ADDENDUM NUMBER 2

PROJECT	BIDS DUE
GFA Project No: 14253	Date: February 7, 2017
City of Clare Recreation Complex	Time: 11:00 AM
Earthwork and Parking Lot	Location: City of Clare
Construction	202 West 5 th Street
	Clare, MI 48617-4508

GRAVEL DETAIL

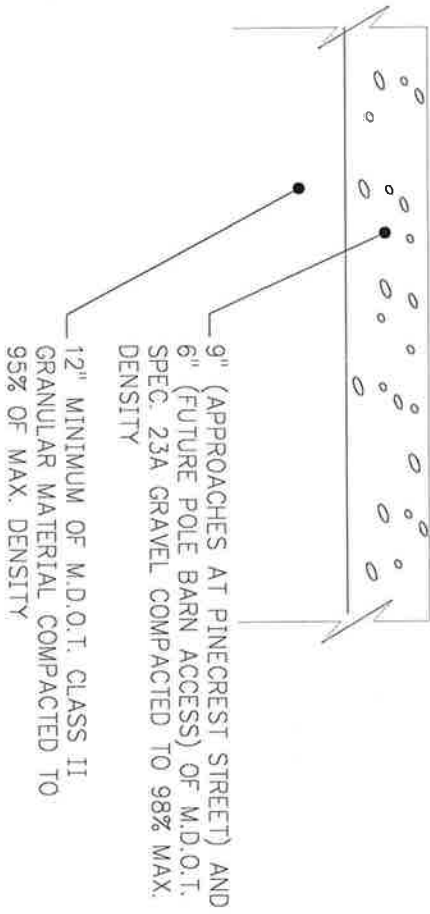
5. Measurement and Payment – Use the Attached Measurement and Payment specification for all Bid Items.
6. Addendum #1 included Sheet 2.1A. This stockpile is available at the City Storage Area indicated on the Plan. The Contractor working on the Afton Stone Path (Phase One), will utilize approximately 600 cubic yards of this stockpile. If additional MDOT Class II material is required, Contractor will need to supply the necessary material from a different source.
7. New Adjusted Bid Tab – Use the Attached Bid Form for Bid Submittals.
8. Delete the following sentences: “Obtain approved borrow soil materials from Phase II when soil materials are not available on-site”, from Section 02230 – Site Clearing 2.1.A1.
9. See Attached 23-A Road Gravel Detail for entrance drives and parking areas, 9” thick at entrances and 6” thick at parking area.
10. Blank Pay Estimate – Please use Attached.
